# Recall Bulletin

**SUBJECT:** Rear Toe Link Adjuster Lock Nut Torque

**MODELS:** 2010-2015 Cadillac SRX  
2011-2012 Saab 9-4X

4138825

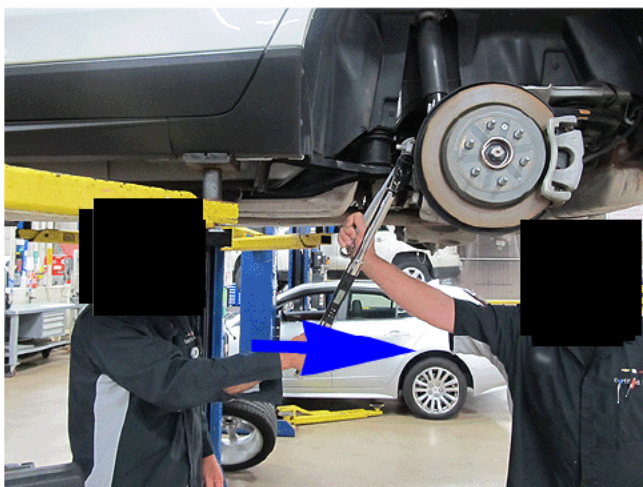
This bulletin has been revised to add a note in the Service Procedure section (see Step 4). Please discard all copies of bulletin 14457B.

Note: Ensure the open end wrench is on the adjustment collar (2) while the jam nut (1) is checked with the torque wrench.
